## Sansui Europe Service Information

SSI-0004E

Models : - 9090, 8080

FIG. 1

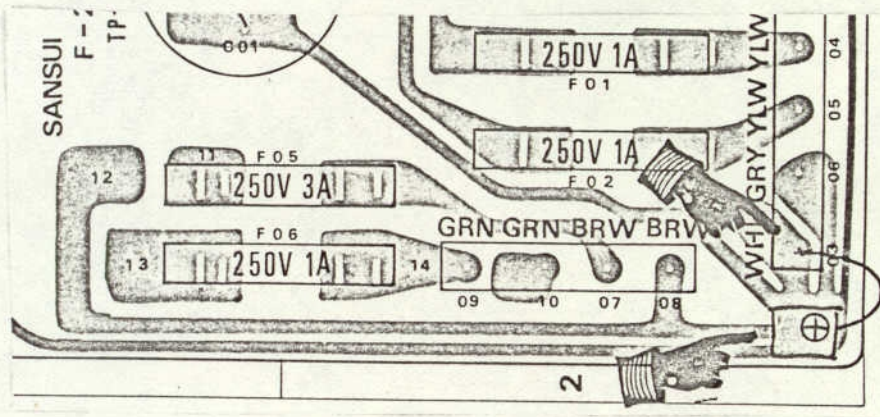
- Resistors R13 and R14, 10 Ohms have to be replaced by special fusing resistors of 4.7 Ohms 1/2 W. See fig. 1.
- The jumper connecting some relay contacts to earth, as shown in fig. 1, has to be removed.

FIG. 2

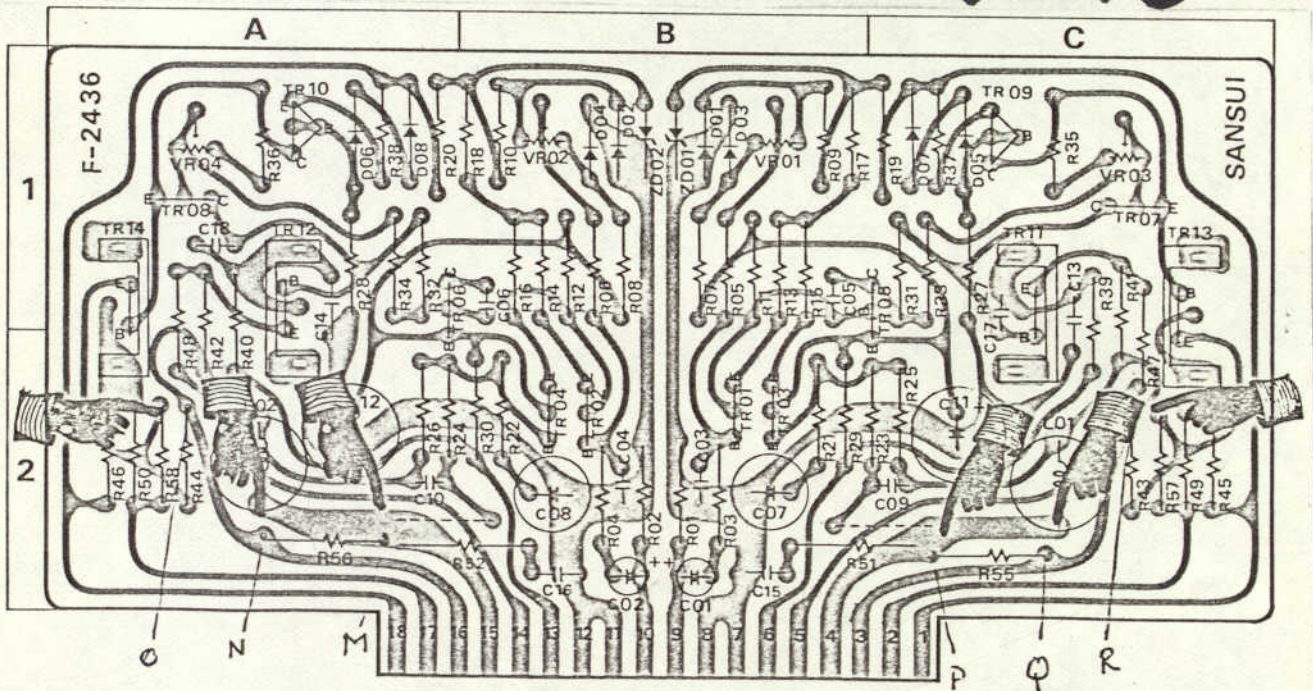
3. The earth contact on P.C.B. F-2546 can be ameliorated by soldering a piece of mesh-lead or any piece of thick, well-conducting wire, from point O3 ( or O6 ) to the adjacent earth lug, as shown in fig. 2.

FIG. 3

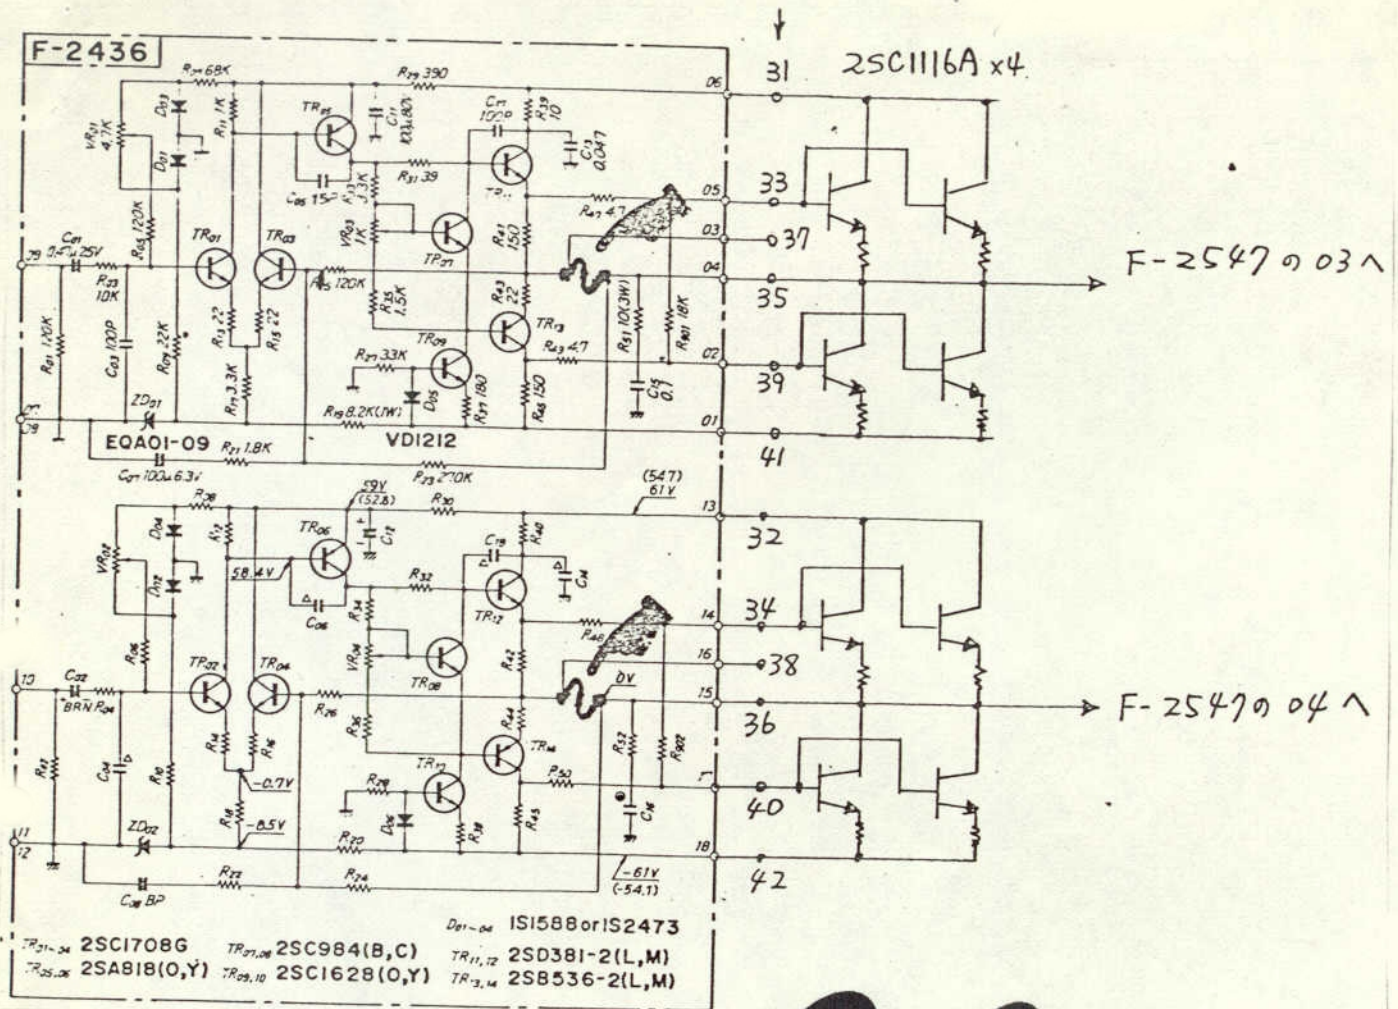
- Connect one wired-in fuse from point M on P.C.B. F-2436-1 ( See fig. 3 ) to point N or to point O, depending upon the position of resistor R44.

- Connect one wired-in fuse from point P on P.C.B. F-2436-1 ( See Fig. 3 ) to point Q or to point R, depending upon the position of resistor R43.

FIG. 4

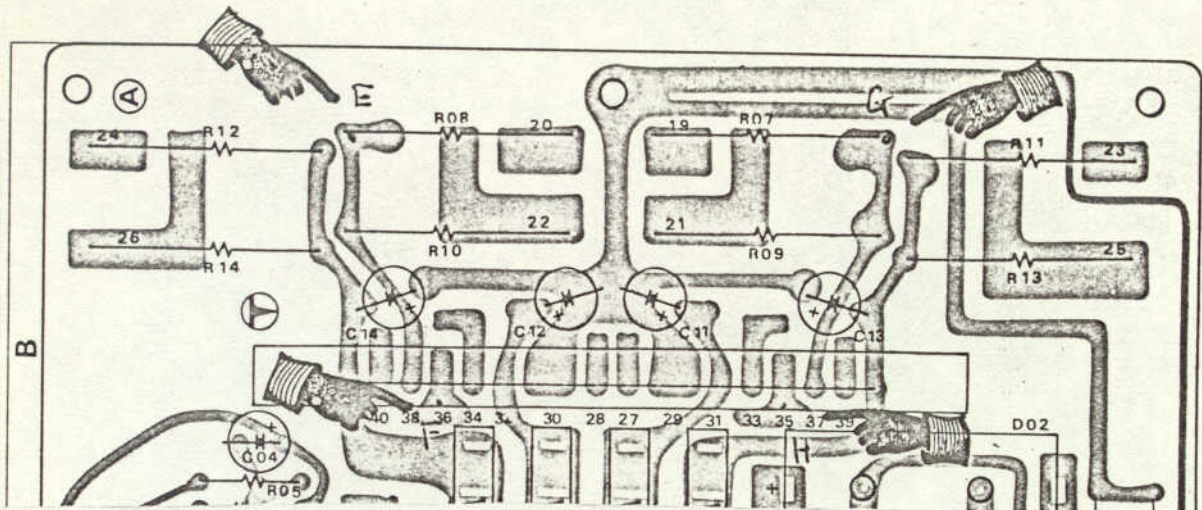
- It is also possible that these connections are made, like shown on fig. 4, from point E to point F and from point G to H. Even so these jumpers should be removed.

- Make the following connections with normal wire :

- from point 04 on F-2547 to point 35 on F-2546

- from point 03 on F-2547 to point 36 on F-2546
